FEASIBILITY STUDY FOR SITE 16 OPEN BURNING AND DISPOSAL AREA NAS WHITING FIELD FL

SITE 16, OPEN DISPOSAL AND BURNING AREA

NAVAL AIR STATION WHITING FIELD
MILTON, FLORIDA

Response to EPA Review Comments
Site 16, Open Disposal and Burning Area
Draft Feasibility Study

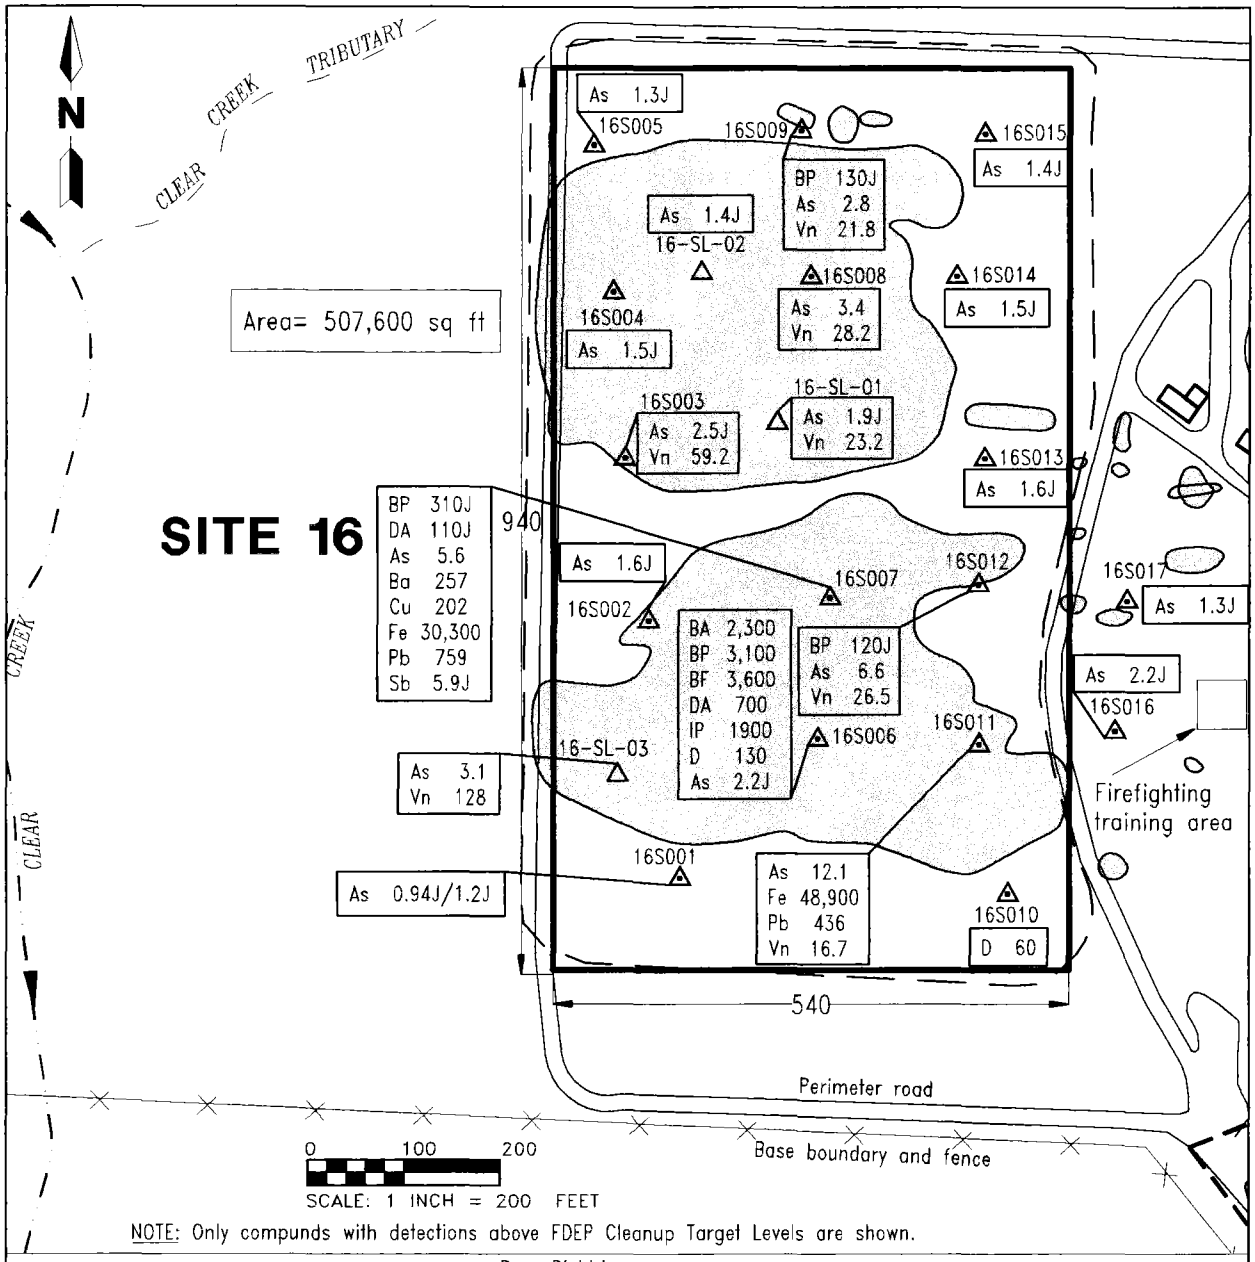
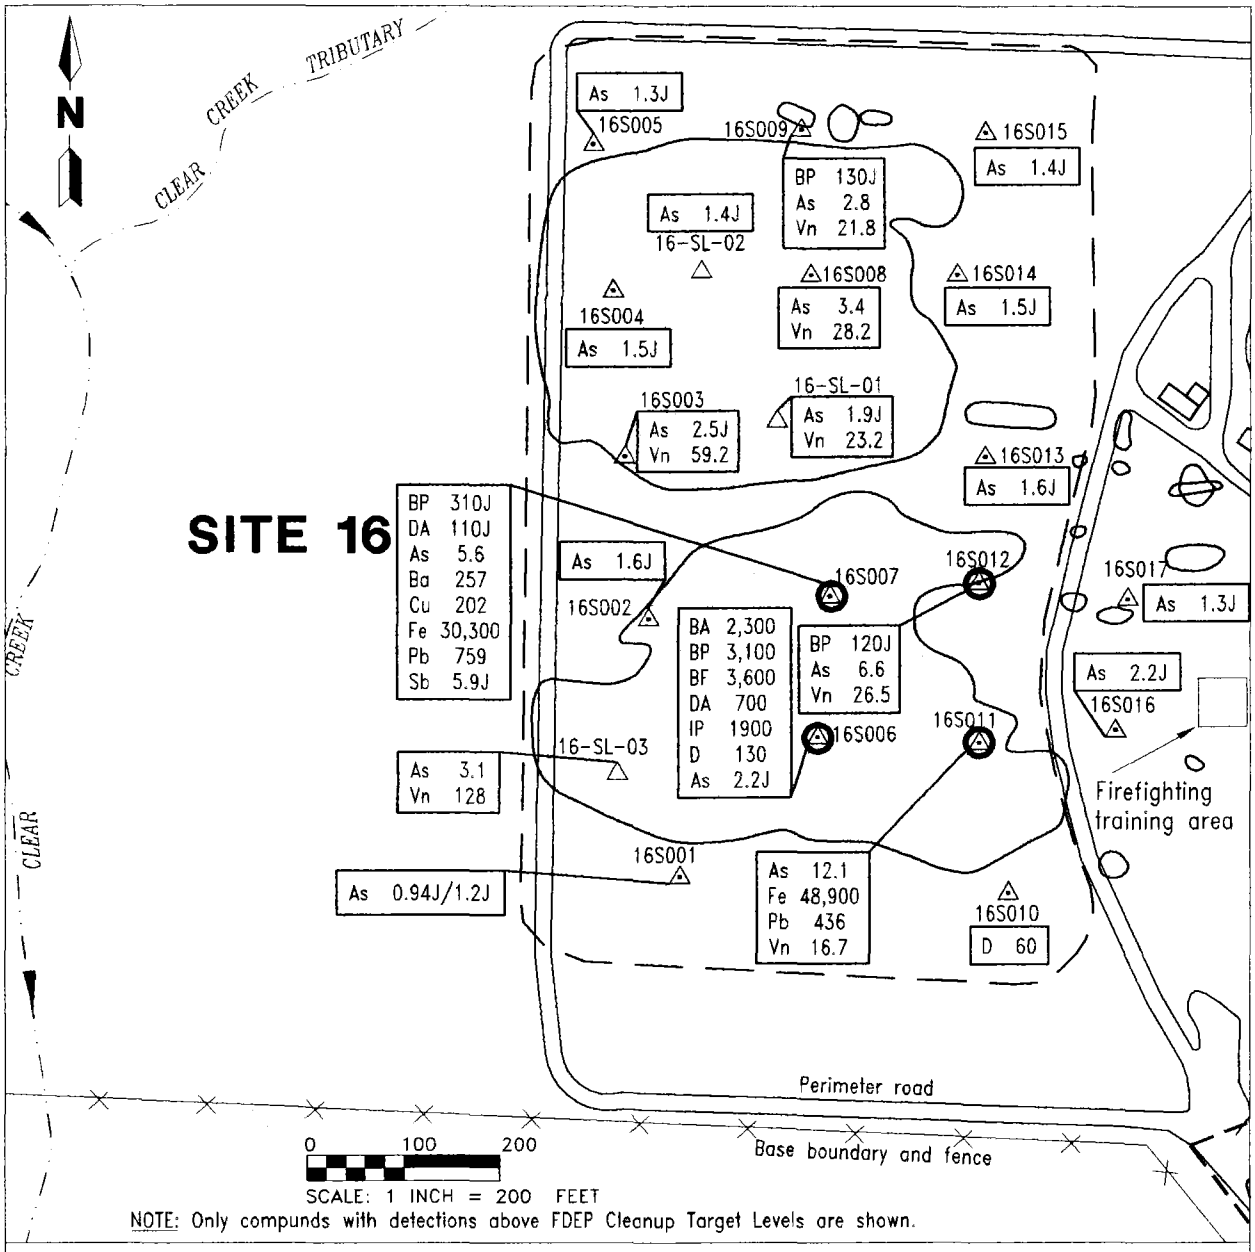
11. Page 5-38: this figure should contain sufficient data to properly correlate the intent; for instance, the data presented do not reflect those locations where cadmium or zinc occur as related to ecological concerns. I recognize that we may not presently have enough data to fully depict all information for this project; however we should depict as much of the data that we can.

Response: Figures presented in Appendix C will be revised to include human health and ecological contaminants of concern.
